Form 3160-5 (June 2019)	UNITED STATES DEPARTMENT OF THE INTERIOR BUREAU OF LAND MANAGEMENT	FORM APPROVED OMB No. 1004-0137 Expires: October 31, 2021
SUNDRY NOTICES AND REPORTS ON WELLS <i>Do not use this form for proposals to drill or to re-enter an abandoned well. Use Form 3160-3 (APD) for such proposals.</i>		5. Lease Serial No. NMNM0438001
		6. If Indian, Allottee or Tribe Name

SUBMIT IN TRIPLICATE - Other instructions on page 2		7. If Unit of CA/Agreement, Name and/or No.
1. Type of Well ☒ Oil Well ☐ Gas Well ☐ Other		8. Well Name and No. DEEP ELEM 4 FED COM/774H
2. Name of Operator EOG RESOURCES INCORPORATED		9. API Well No. 30-015-48260
3a. Address 1111 BAGBY SKY LOBBY 2, HOUSTON, TX 770	3b. Phone No. (include area code) (713) 651-7000	10. Field and Pool or Exploratory Area Purple Sage/Wolfcamp Gas
4. Location of Well (Footage, Sec., T.,R.,M., or Survey Description) SEC 4/T26S/R31E/NMP		11. Country or Parish, State EDDY/NM

EOG respectfully requests an amendment to our approved APD for this well to reflect the following changes:

Deep Elem 4 Fed Com 752H (FKA 774H) API #: 30-015-48260

Revised Wellbore

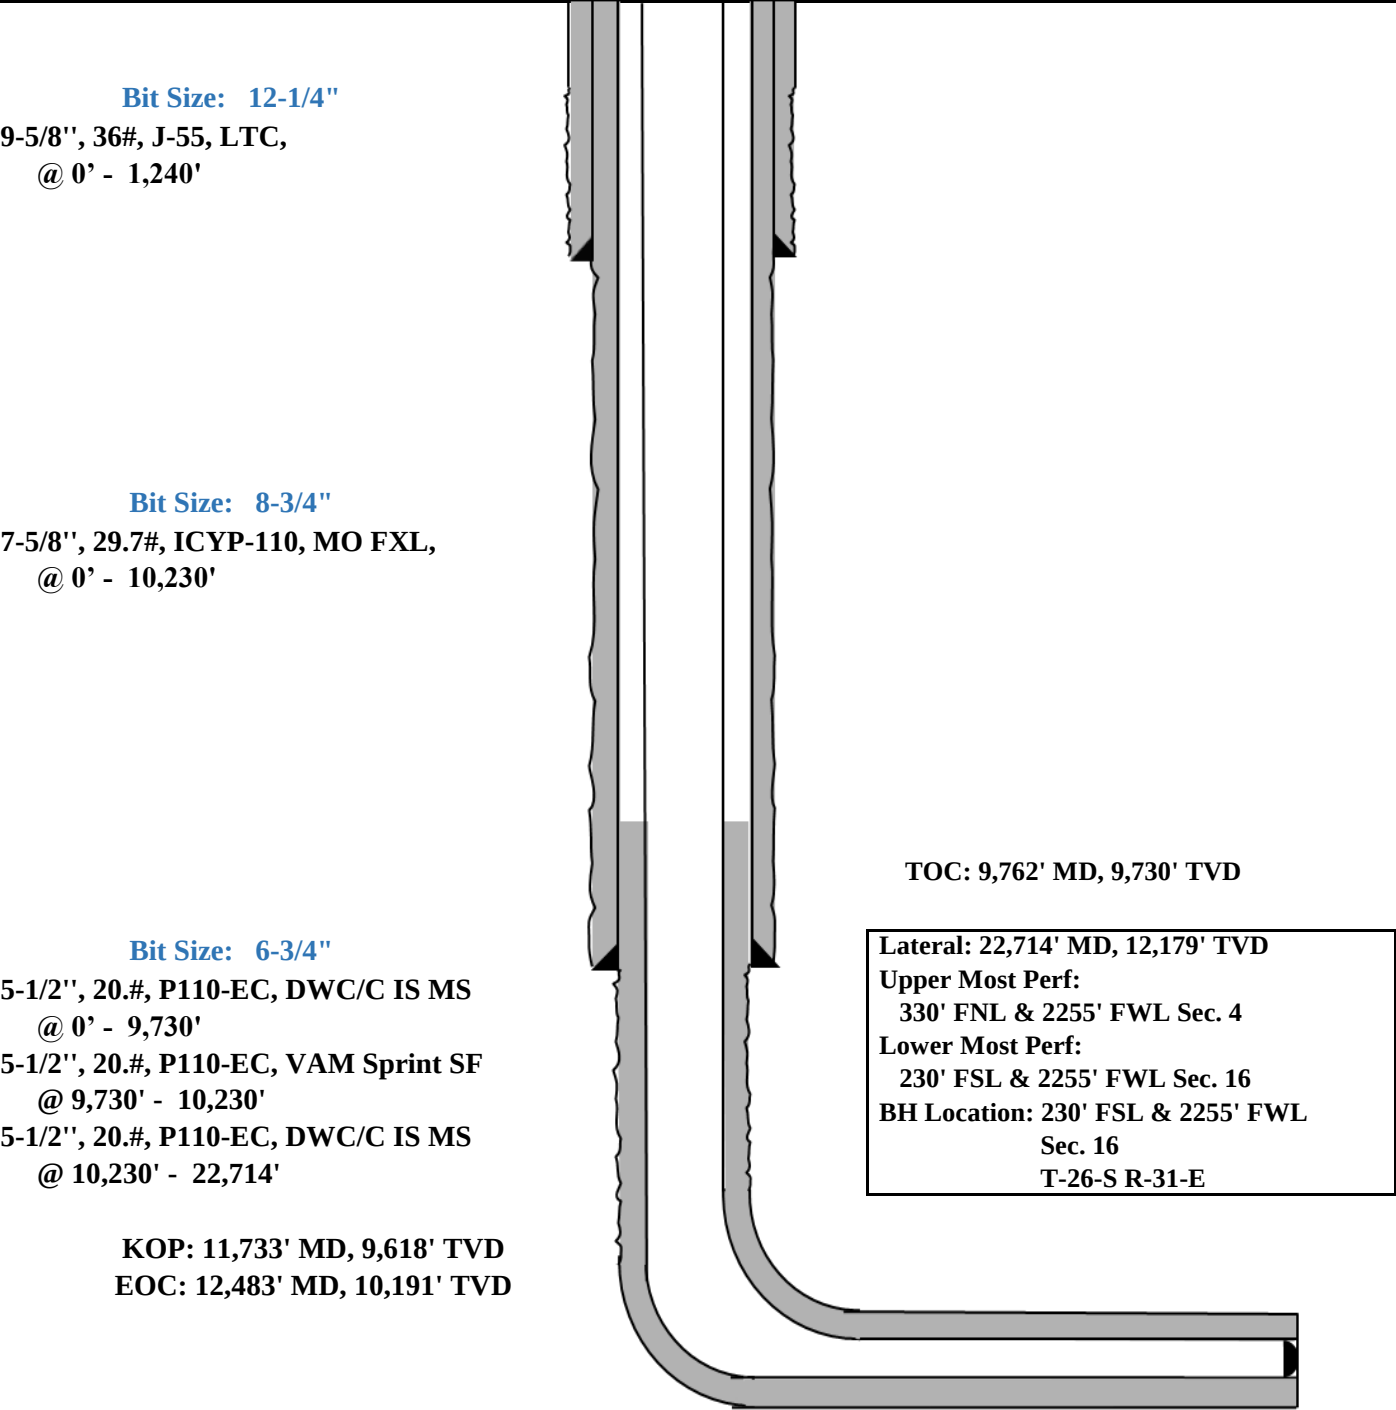
Update casing and cement program to current design.

9-5/8", 36#, J-55, LTC,
@ 0' - 1,240'

7-5/8", 29.7#, ICYP-110, MO FXL,
@ 0' - 10,230'

5-1/2", 20.#, P110-EC, DWC/C IS MS
@ 0' - 9,730'
5-1/2", 20.#, P110-EC, VAM Sprint SF
@ 9,730' - 10,230'
5-1/2", 20.#, P110-EC, DWC/C IS MS
@ 10,230' - 22,714'
